# Access Compliance Report

## Public Rights-of-Way

Intersection ID: 13098	Main Street: S_CHURCH_ST	Cross Street: LINCOLN_ST	Location: W
ADA ID: 8B24818D2018	Ramp Type: PerpDiag	Initial Pass/Fail: Fail	Overall Compliance: No
		Severity Score: 8.75	
Codes/Mitigation Info/Possible Solution		Field Measurements/Component Compliance

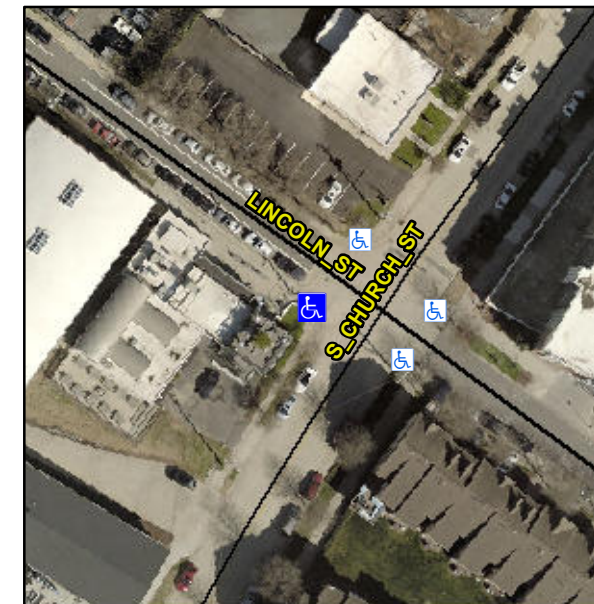
**Not Found, R304.5.1**

Compliance	Description	Data	Compliance	Description	Data
N/A	Ramp Length (in)	82.0	Yes	Ramp Slope (%)	7.5
No	Ramp Width (in)	36.0	Yes	Ramp XSlope (%)	1.2
N/A	Flare Type LT	N/A	N/A	Flare Type RT	N/A
N/A	Flare Slope LT (%)	N/A	N/A	Flare Slope RT (%)	N/A
N/A	Flare Traversable LT?	N/A	N/A	Flare Traversable RT?	N/A
N/A	Landing Length (in)	N/A	N/A	DWS Provided?	N/A
N/A	Landing Width (in)	N/A	N/A	DWS Contrast?	N/A
N/A	Landing Slope (%)	N/A	N/A	DWS Length (in)	N/A
N/A	Landing X Slope (%)	N/A	N/A	DWS Full Width?	N/A
N/A	Landing Curb? (Y/N)	N/A	N/A	DWS Offset (in)	N/A
N/A	Shared Landing?	N/A			
N/A	Gutter Ponding?	N/A	N/A	Gutter Slope (%)	N/A
N/A	Gutter Lip Ht (in)	N/A	N/A	Gutter X Slope (%)	N/A
N/A	Painted X Walk1?	No	N/A	Painted X Walk2?	No
	X Walk 1 Direction	To SE		X Walk 2 Direction	To NE
N/A	X Walk 1 Width (in)	N/A	N/A	X Walk 2 Width (in)	N/A
	X Walk 1 Slope (%)	1.8		X Walk 2 Slope (%)	1.2
	X Walk 1 X Slope (%)	1.9		X Walk 2 X Slope (%)	1.4

**Remove & Replace Curb Ramp With Two New Directional Ramps or Equivalent.**
